Access Compliance Report

Public Rights-of-Way

(Curb Ramps)

Intersection ID: N/A	Main Street: S COLLEGE ST	Cross Street: HILL ST	Location: N
ADA ID: 3050DE0E4A74	Ramp Type: Para	Initial Pass/Fail: Pass	Overall Compliance: No
Codes/Mitigation Info/Possible Solution		Field Measurements/Component Compliance	
Severity Score: 0.25

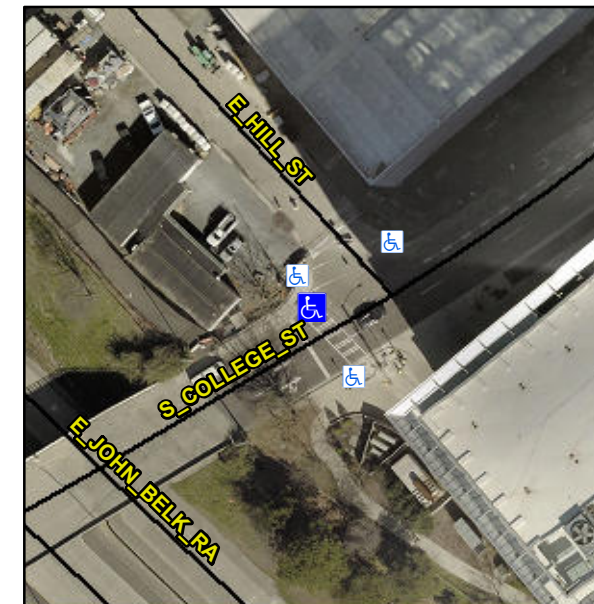
**Remove & Replace Entire Ramp.
Remove & Replace Gutter.**

**R304.5.3, R304.2.2-Perp, R304.3.2-
Para**
